**LINCOLN PARK PLANNING COMMISSION**  
CITY HALL – COUNCIL  
CHAMBERS 1355 SOUTHFIELD  
ROAD LINCOLN PARK, MICHIGAN

## UAW-Ford Technical Training Center Revitalization Site Plan Review

Applicant	DiClemente Siegel Design Inc.
Project	UAW-Ford Technical Center Revitalization
Address	28105 Greenfield Road, Southfield MI 48076
Date	September 13, 2017
Request	Site Plan Approval
Recommendation	<b>Approval</b>

**PROPOSED OVERALL ELEVATIONS**

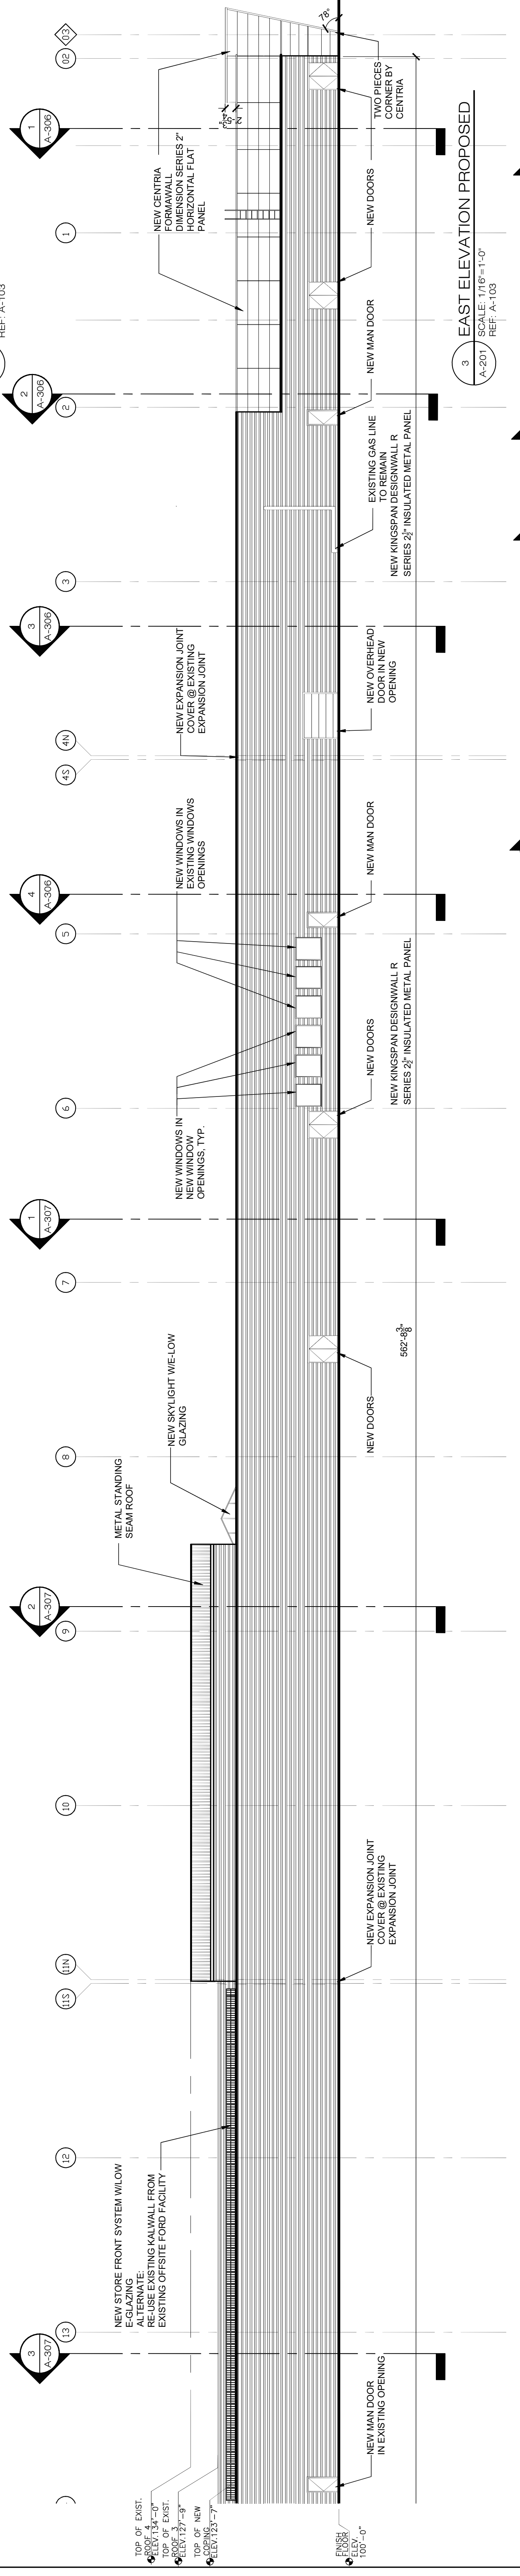
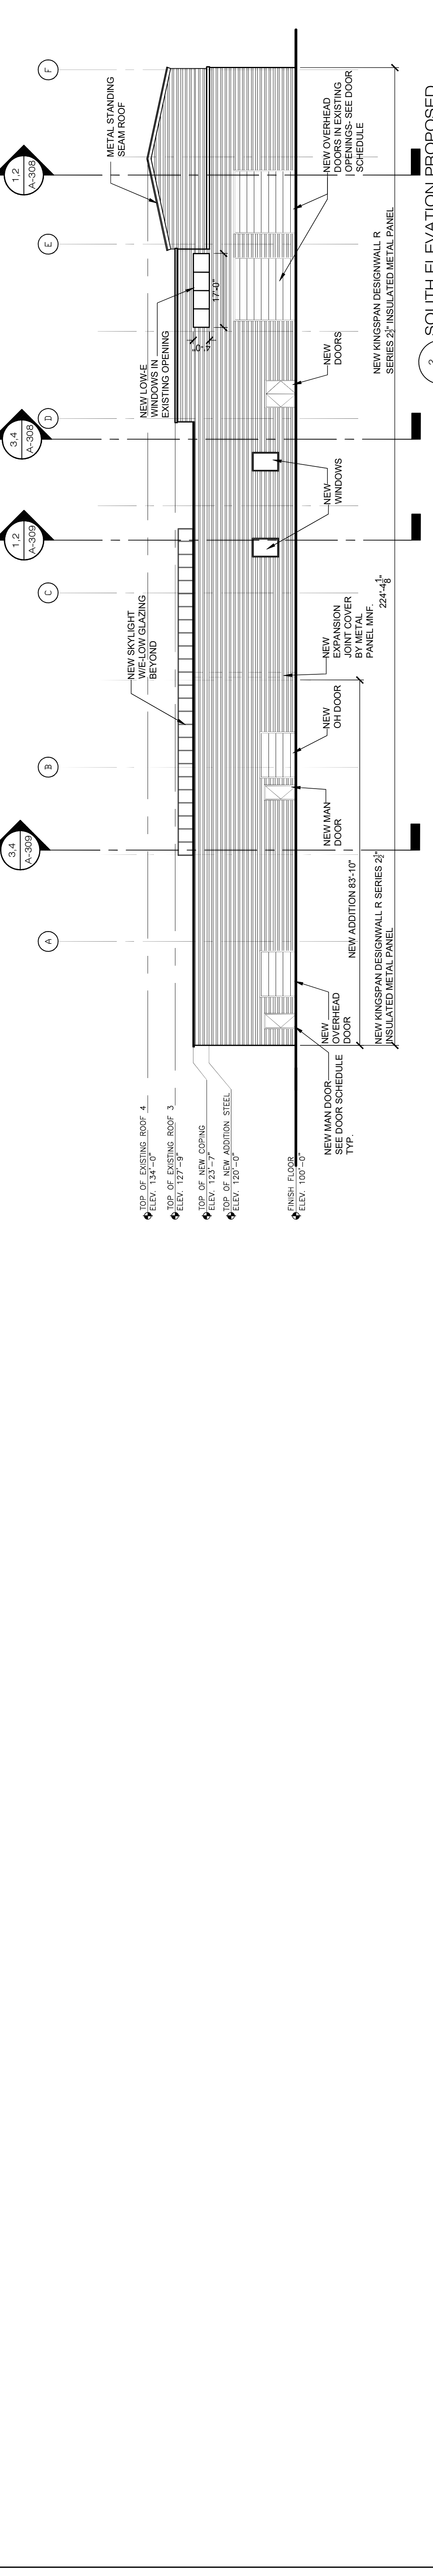
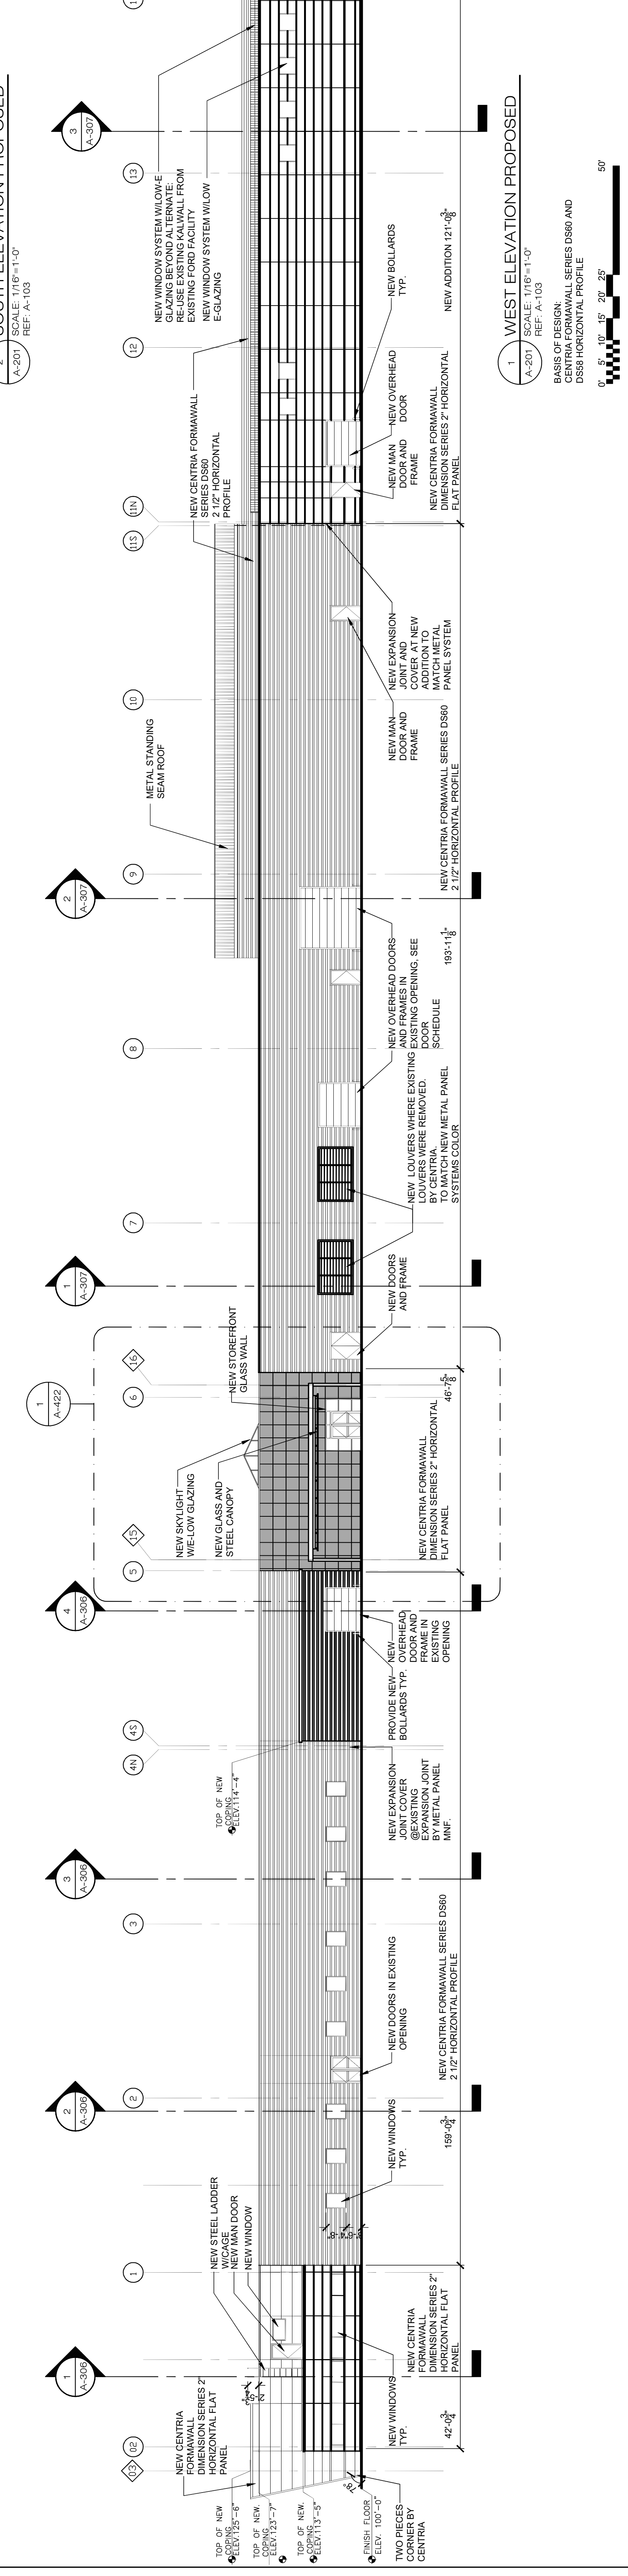
Architectural elevations were not included in the applicant’s site plan submittal dated September 1, 2017. It was confirmed with the applicant that architectural sheets included in a previous submission, dated April 10, 2017 and received by the City in June 2017, should be referenced. Sheet A-201 was referenced for this review. Applicant shall submit a fresh copy of all additional sheets, which were not submitted to the City of Lincoln Park on September 5, 2017, which should be included with this site plan package.

- Applicant to submit a fresh copy of all additional sheets, which were not submitted to the City of Lincoln Park on September 5, 2017, and which the applicant wishes to be included with this site plan package
- Applicant to supply building façade materials with percentages
- Applicant to address window orientation, spacing arrangements, and façade composition

The proposed site plan for UAW-Ford Technical Training Center Revitalization, dated September 1 2017 and incorporating sheet A-201 dated April 10 2017, is substantially in compliance with §1296.01, Site Plan Review, with the following conditions and waivers.
